FORT STREET PUBLIC SCHOOL

s.4.55 Modification 2: Heritage Impact Statement

Prepared by Curio Projects for Lendlease

November 2022

Figure 4-1. Proposed floor level amendments in Building G, H and J. Source. FJMT, 17 October 2022.

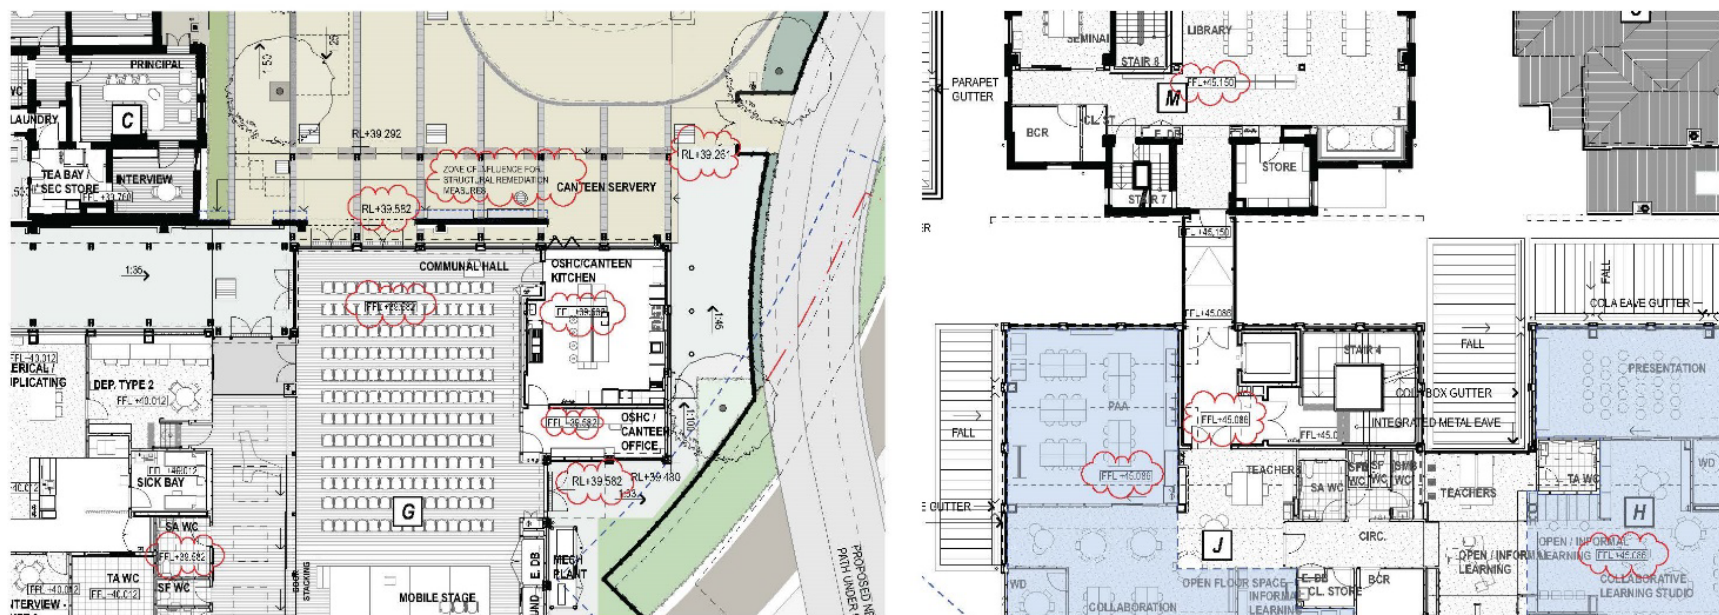
Where floor levels are proposed to be lowered in Buildings G by 172mm, some external finished levels will change, however these are considered a positive impact as they will improve connections between buildings and no internal reconfigurations are required. In addition, the approved s4.55 Mod 1 building height will be retained.

These proposed works would involve minor changes to the finished floor level of Buildings H and J only, as approved in the s4.55 Mod 1 designs. Where floor levels are proposed to be reduced in Building H and J by 86mm, changes will only modify the internal floor level, and no external change to the volume, height or scale of the approved form is required. The only visible change associated with these works will be minor amendments to glass facades and sills, however these will not be visible externally. Therefore, visual impacts are considered **neutral**, as changes will not be visible externally and will only impact modern fabric.

The lowering of floor levels in Buildings G and H will require excavations to 86mm and 172mm deeper than approved in s4.55 modification 1 designs. An assessment of archaeological potential within these building footprints in the 2021a ARD indicated that there is low potential for archaeological resources to be present in these areas due to previous disturbance associated with the gradual development of the Cahill Expressway, FSPS and its ancillary buildings. Therefore, no impacts to significant archaeological resources are anticipated as a result of these proposed changes to approved s4.55 Mod 1 designs.

Figure 4-4. Proposed lift overrun amendment, Building J. Source. FJMT, 17 October 2022.

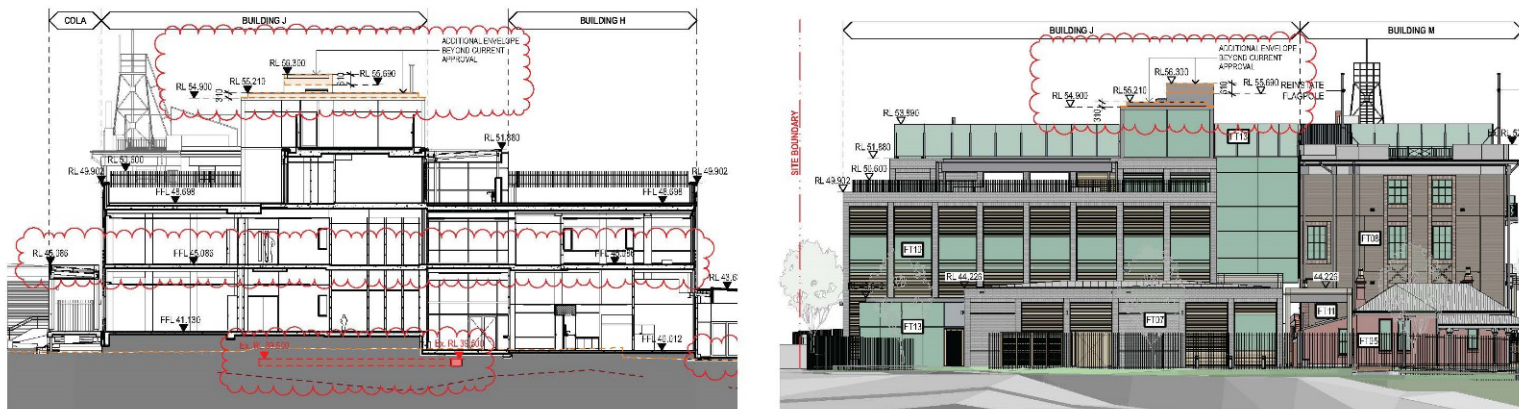
- **Lift Overrun amendment in Building J**
 - These proposed works would involve raising the lift shaft roof and stair lobby roof by 610mm and 310mm, respectively. While this does represent a minor visual impact in comparison to the approved SSD and s4.55 Modification 1 designs, the final design has been developed in close consultation with DPENSW and on balance it is considered to be sufficiently offset by the reduction in Buildings F, G, H and J floor levels.

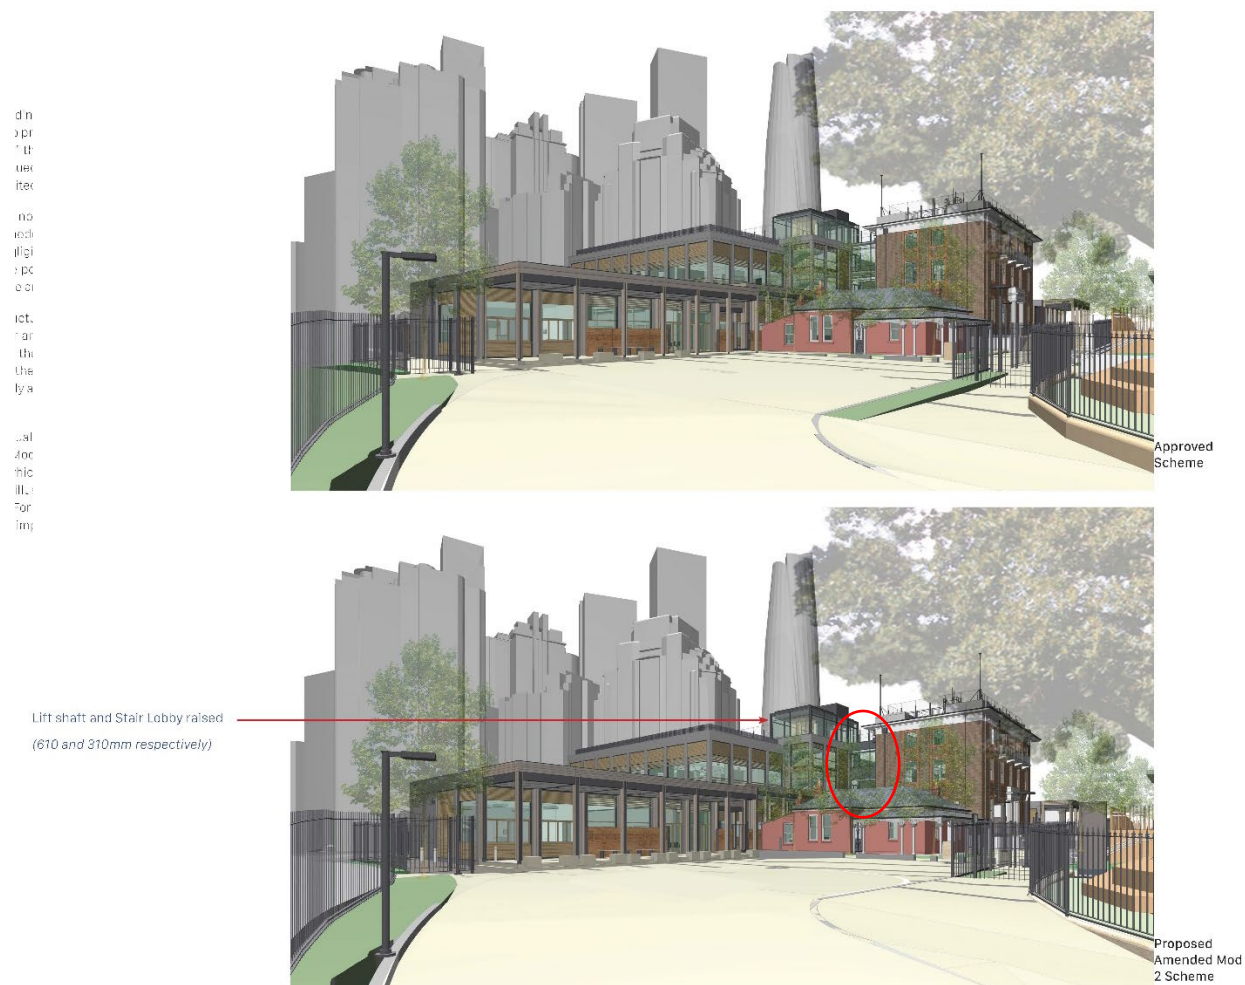
While the design merits of the approved scheme have been maintained, the addition of the horizontal spandrels will reduce the risk of adverse impact to the MET Building in the event of a fire in Building J, they will have an additional visual impact on views to the FSPS site from the south, east and west. The requirement for horizontal spandrels will reduce the discreet nature of the approved s4.55 Mod 1 designs for the bridge. FJMT in response to the design change noted that:

Whilst the change in materiality, including the introduction of the spandrels will have an additional minor impact on views to the FSPS site from the south, east and west, the fire safety requirement for the design change is of paramount importance, particularly within a primary school setting.. In addition, the new BCA and fire compliant spandrels will reduce the risk of adverse impact to the MET Building in the event of a fire in Building J.

Figure 4-9. Comparison of views looking north from the National Trust towards the approved s4.55 Mod 1 designs (top) and proposed amended s4.55 Mod 2 scheme (bottom) showing raised lift shaft overrun and stair lobby. Proposed horizontal spandrels circled in red. Source. FJMT, 17 October 2022.

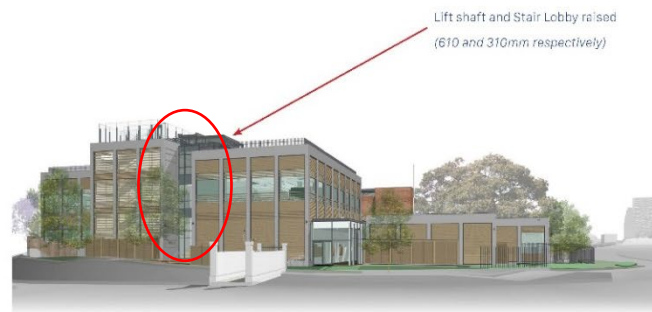
Three solid horizontal spandrels will be incorporated into the lift stair lobby to address determinations from the fire engineer and BCA consultant	The approved s4.55 Mod 1 design for the stair lobby will be modified to allow for the inclusion of three solid horizontal spandrels as illustrated in Figure 4-5 to Figure 4-9.	No physical impacts Minor visual impacts Nil- minor archaeological impacts
